# 1515 EARL ARMSTRONG PLAZA

**CONTRACT NO. 137404**

SHEET TITLE  
GENERAL PLAN

SHEET NUMBER  
001

SHEET NUMBER  
**200**

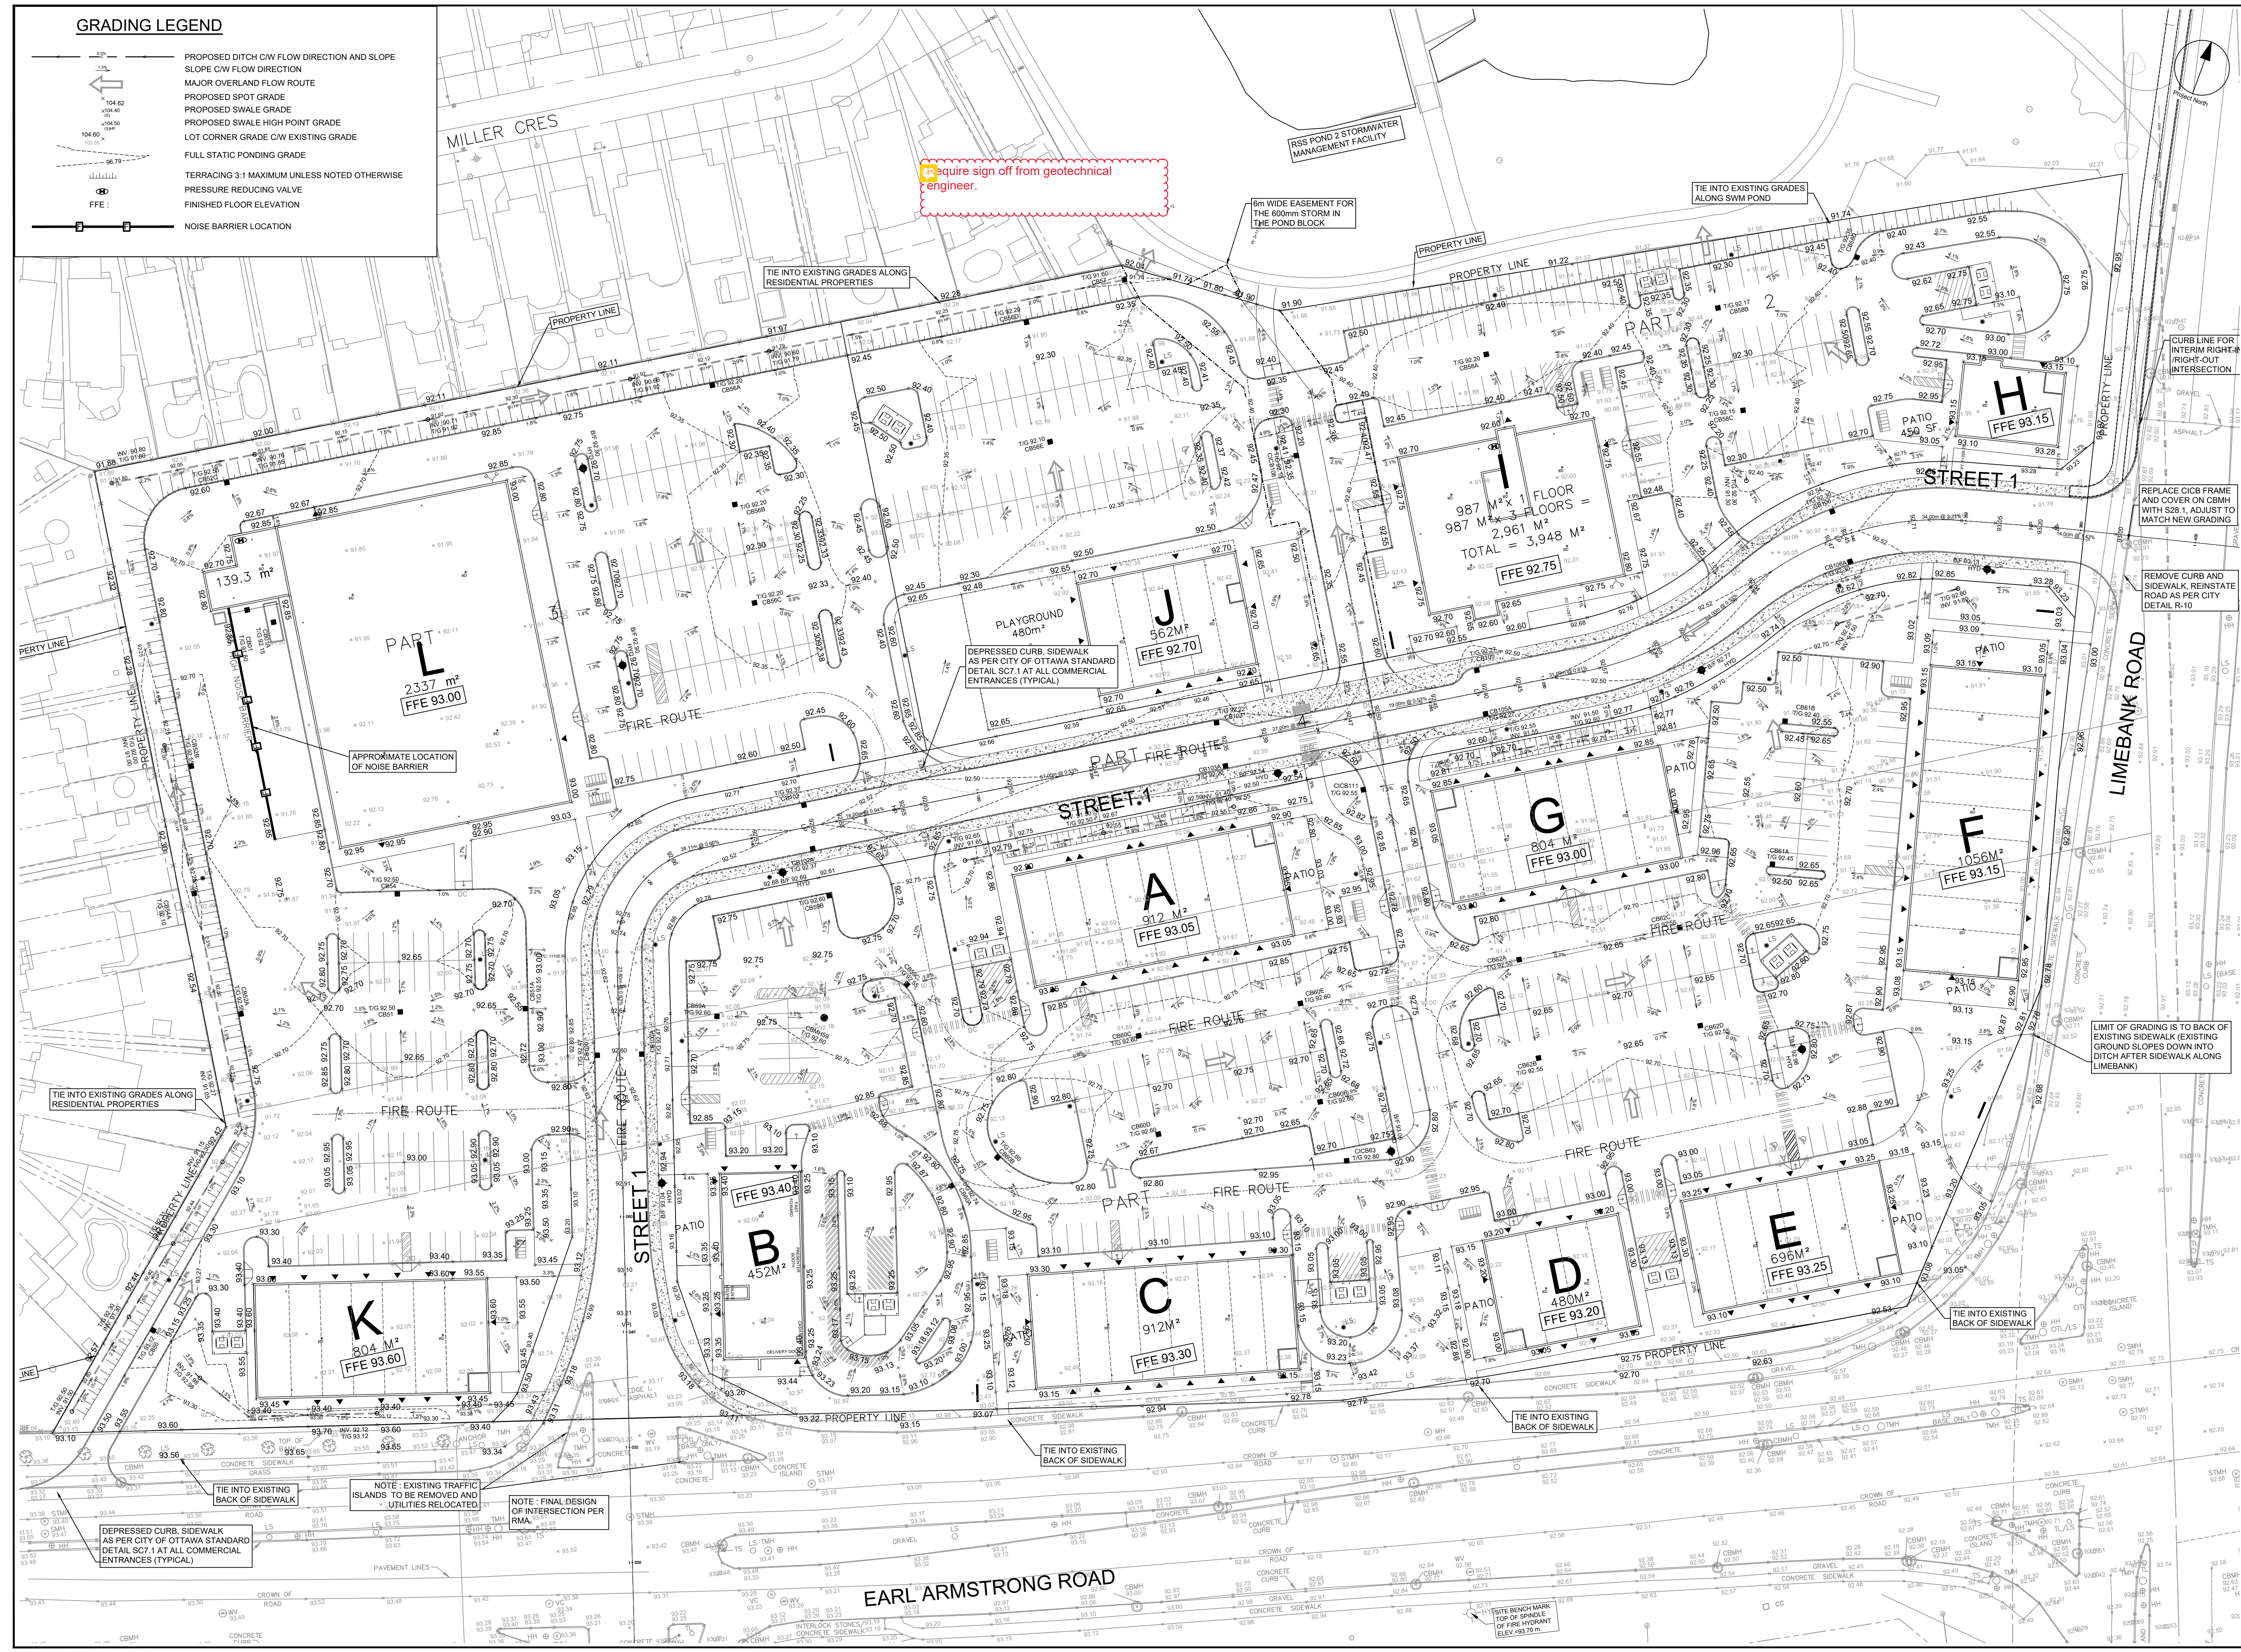
Require sign off from geotechnical engineer.
